<b>Docket Number:</b>	06-AFC-09C
<b>Project Title:</b>	Colusa Generating Station - Compliance
<b>TN #:</b>	216317
<b>Document Title:</b>	Pacific Gas & Electric Company's Petition to Amend for Colusa Generating Station ACC Pump Pit Stairway
<b>Description:</b>	N/A
<b>Filer:</b>	Marie Fleming
<b>Organization:</b>	DayZen LLC
<b>Submitter Role:</b>	Applicant Representative
<b>Submission Date:</b>	3/2/2017 9:58:38 AM
<b>Docketed Date:</b>	3/2/2017

# PETITION TO AMEND

COLUSA GENERATING STATION (06-AFC-9C)

## ACC SUMP AND PUMP PIT STAIRWAY

DRAWING TITLE:  
**STAIRWAY LAYOUT**  
 ACC SUMP AND PUMP PIT  
 COLUSA GENERATING STATION

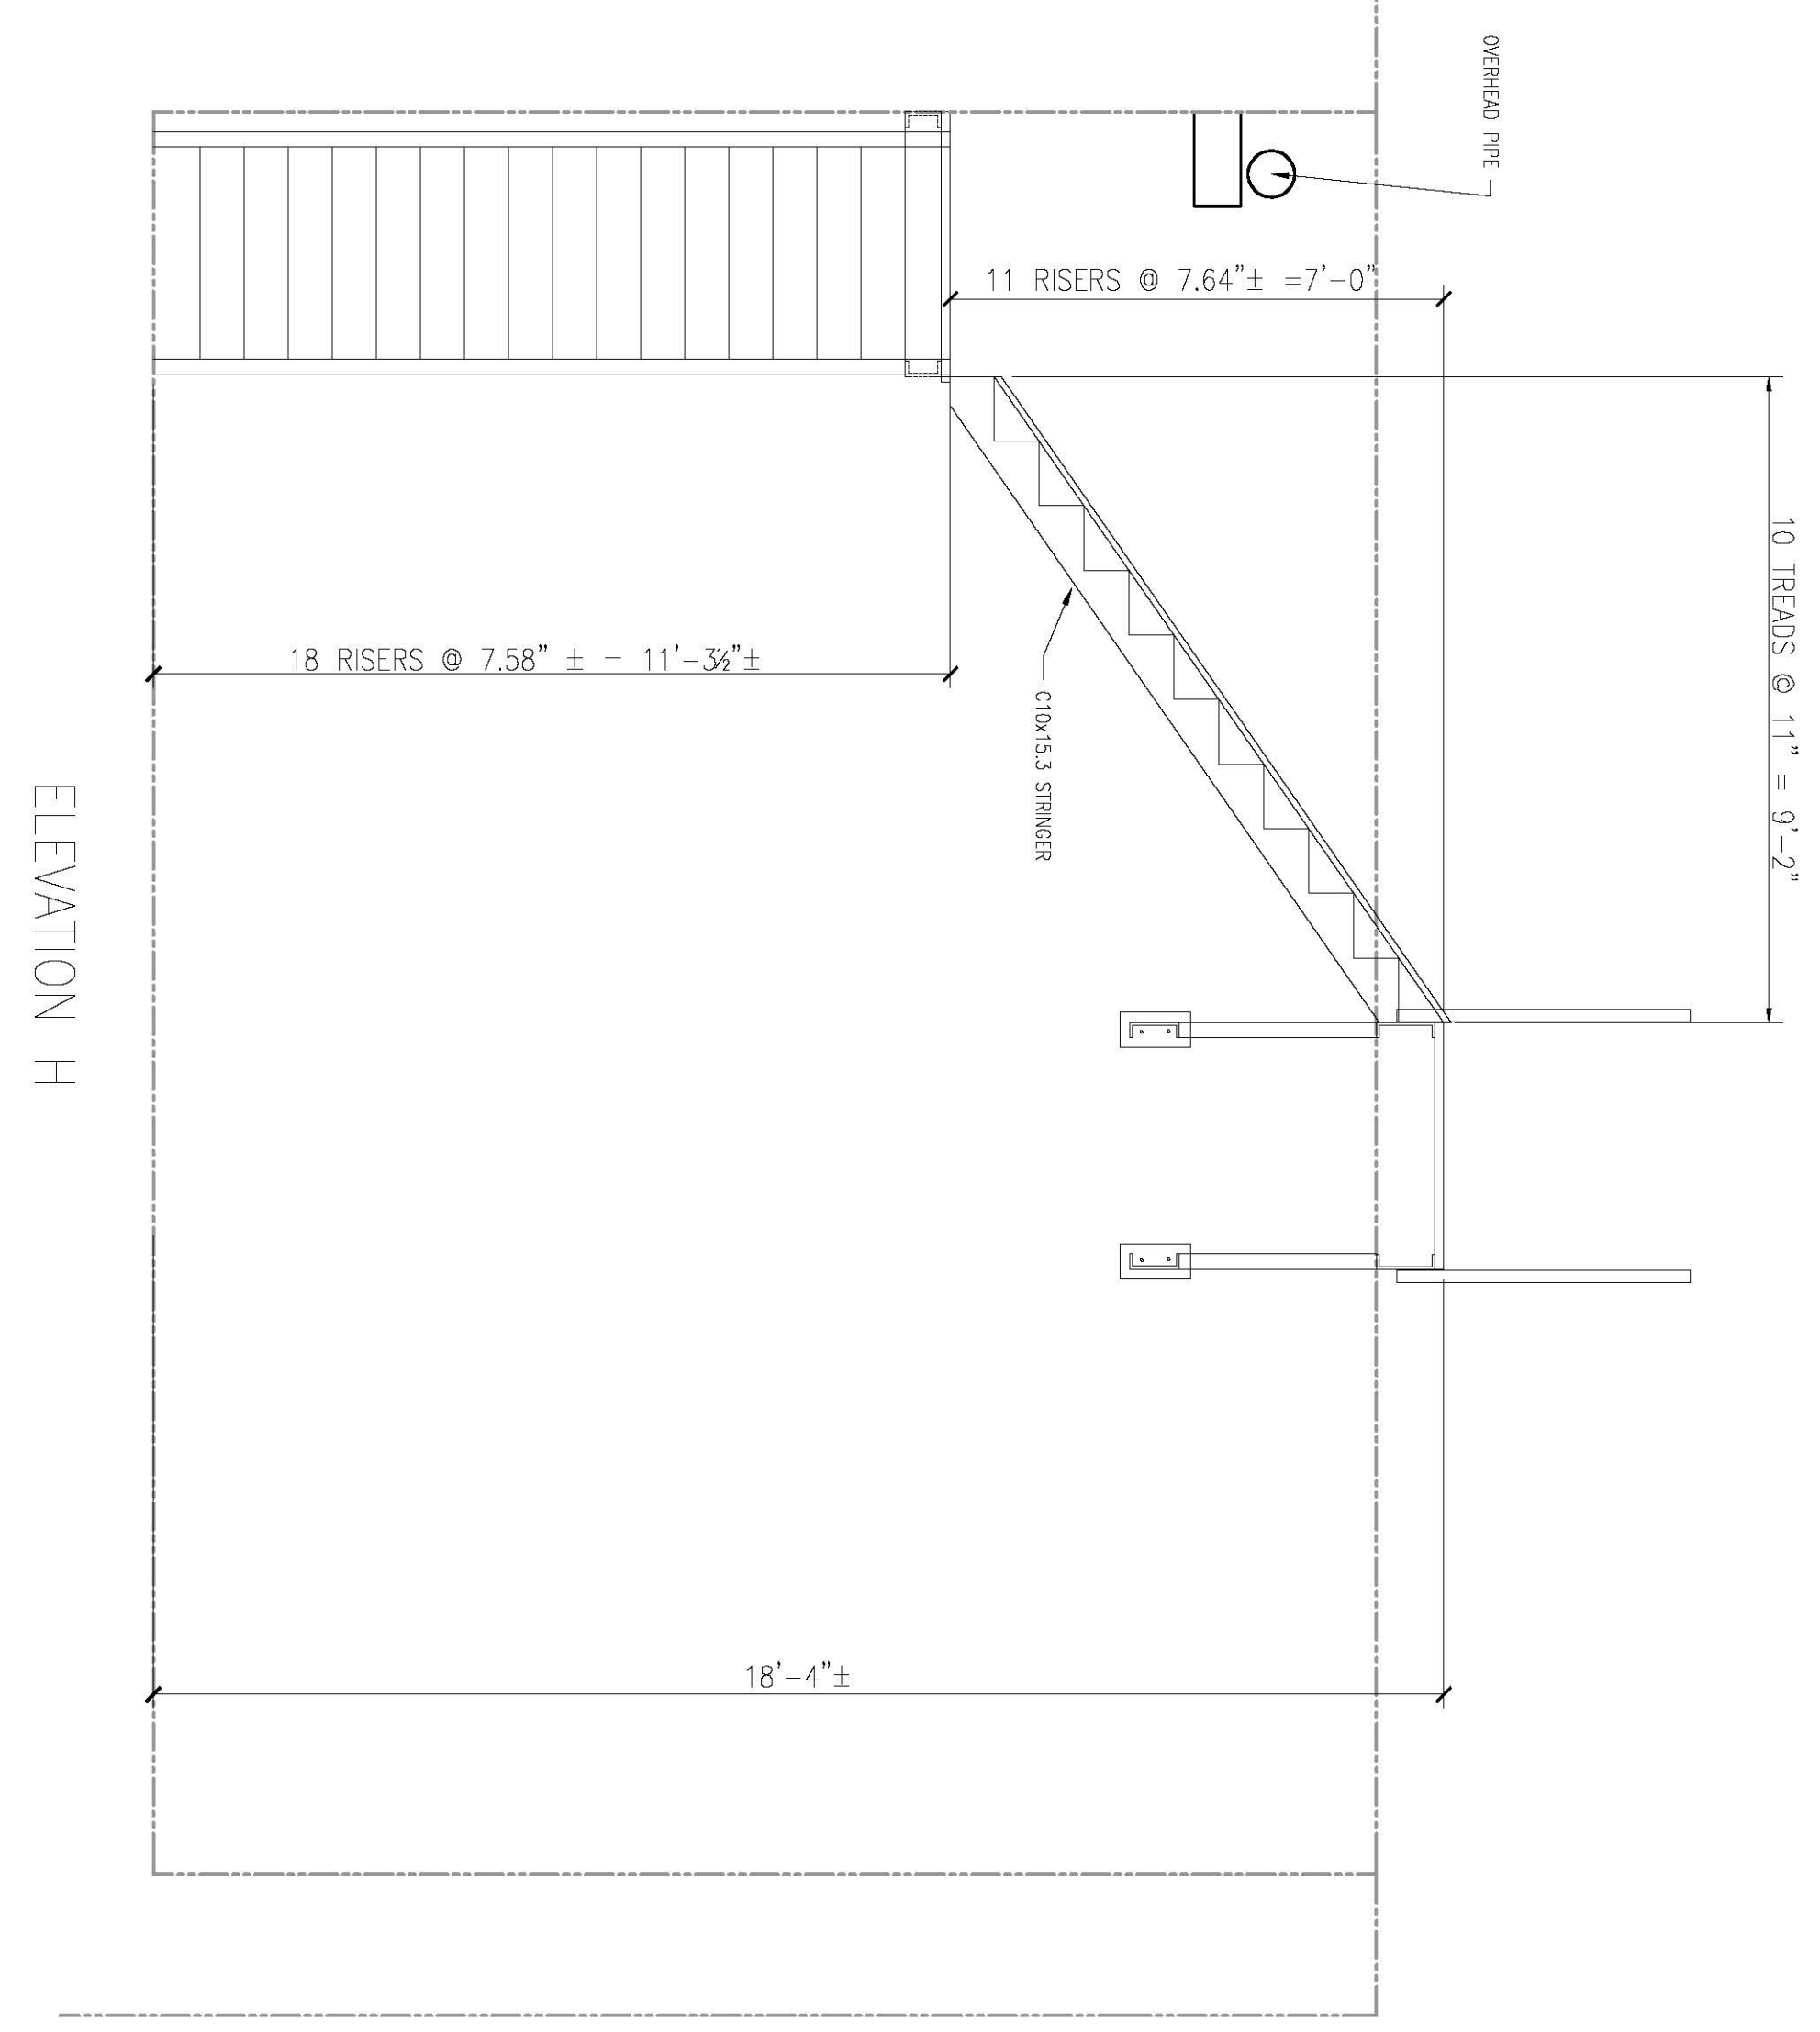
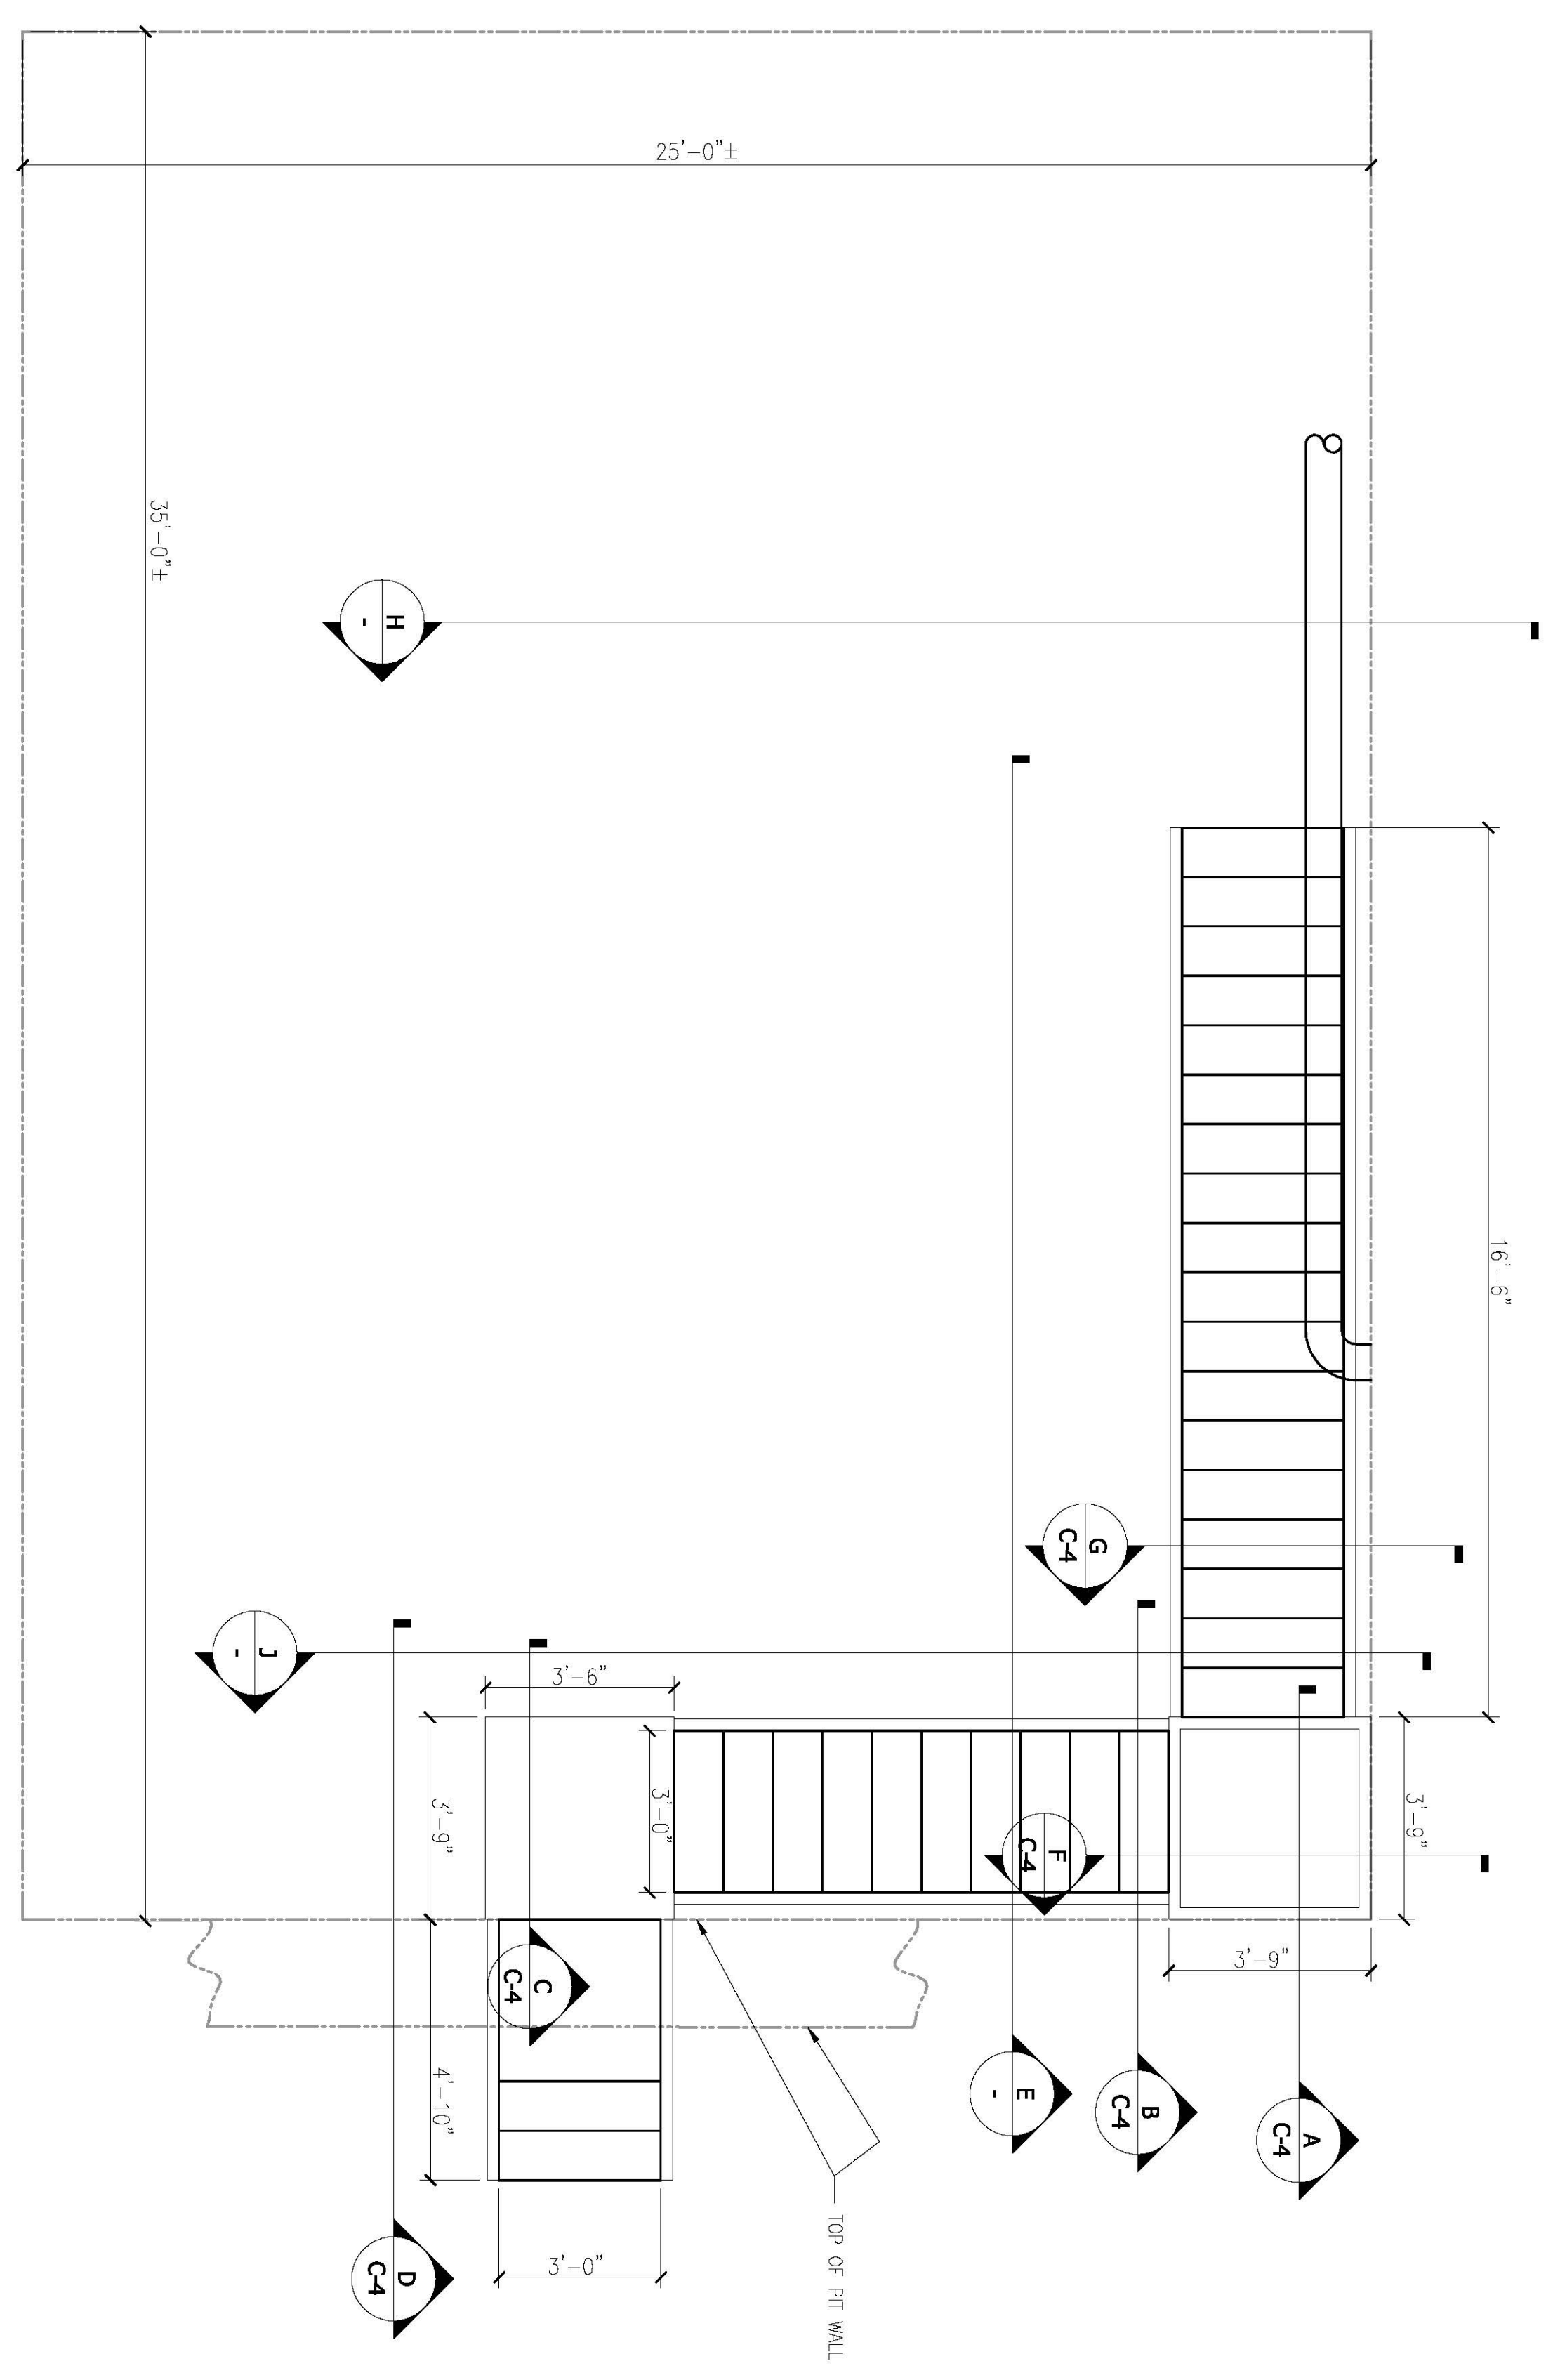
PG&E is proposing in this Petition For Amendment to install a permanent stairway to access two condensate return pumps for the Air Cooled Condenser (ACC). The ACC steam duct has a low point to collect all condensate to return it to the condensate tank for usage. The bottom part of this steam duct is below grade, housed in a pit that is approximately 17-1/2 feet deep. Two condensate return pumps are located at the bottom of this pit which are currently accessed via a ladder.

The use of the ladder has proven inefficient for operators and/or maintenance personnel in accessing the condensate return pumps. Personnel are limited in transporting tools up and down the ladder. The installation of the permanent stairway will be much safer and efficient.
